1R - 428-76

From: Katie Jones <kjones@riceswd.com>
Sent: Wednesday, August 28, 2013 9:55 AM
To: Hansen, Edward J., EMNRD
Cc: Hack Conder; Laura Pena; Lara Weinheimer
Subject: ROC - Hobbs M-4 vent (1R428-76) CAP Addendum

**RE: Corrective Action Plan (CAP)
Rice Operating Company – Hobbs SWD System
Hobbs M-4 vent (1R428-76): UL/M sec. 4 T19S R38E**

MW Sampling Data

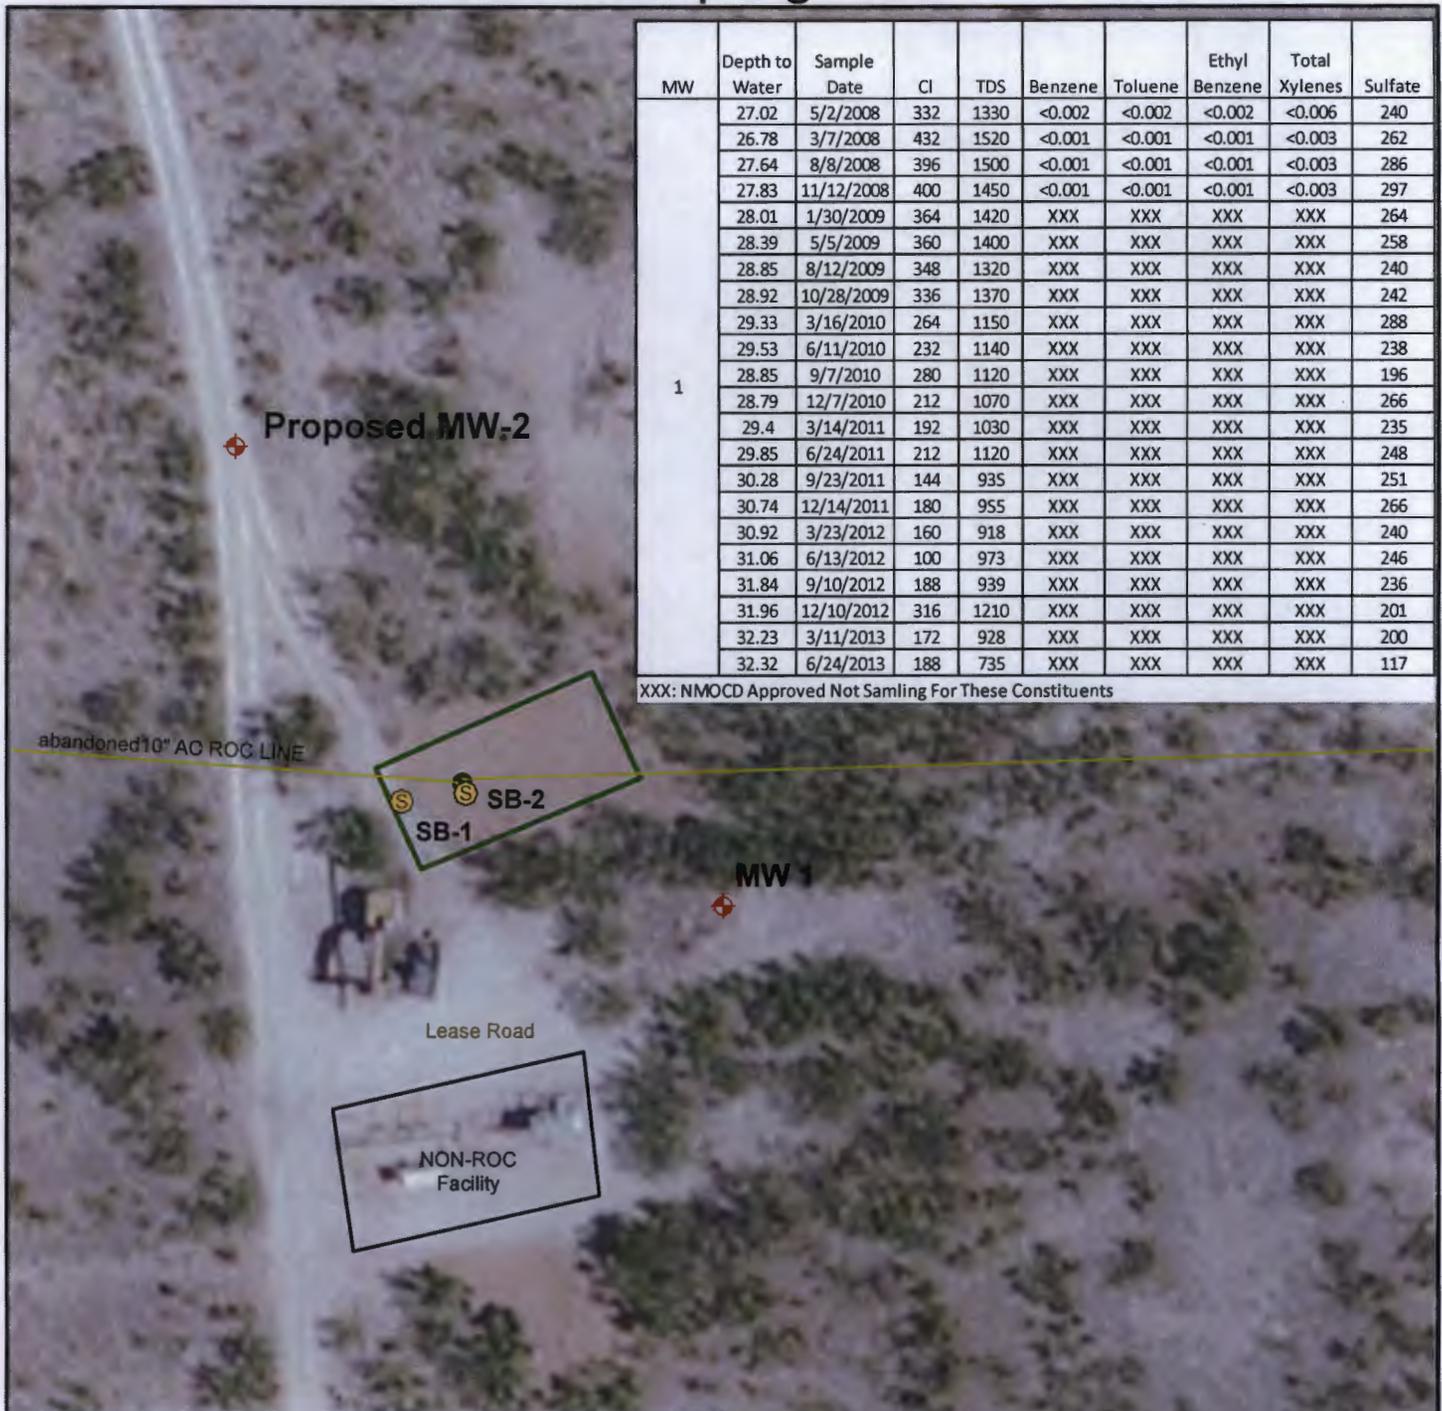
Monitoring of the near-source well (MW-1) has shown chloride concentrations consistently near or below 250 mg/L. The two most recent quarterly samples resulted in a concentration of 172 mg/L and 188 mg/L, respectively. Based on these recent samples, ROC proposes to continue monitoring MW-1 for two additional quarters to determine if concentrations will remain below WQCC standards. After the two quarters are obtained, ROC will submit a report with recommendations. ~~In order to determine if there is an up-gradient groundwater source for contamination at the site, RECS recommends that ROC install a monitor well (MW-2) approximately 100 ft up gradient of the site (Figure 2). The monitor well will be sampled quarterly in conjunction with MW-1. Once the monitor wells at the site have been analyzed for chloride and TPH readings, ROC will either submit a groundwater remedy to NMOCD to address groundwater quality at the site or submit a ‘remediation termination’ request for site closure.”~~
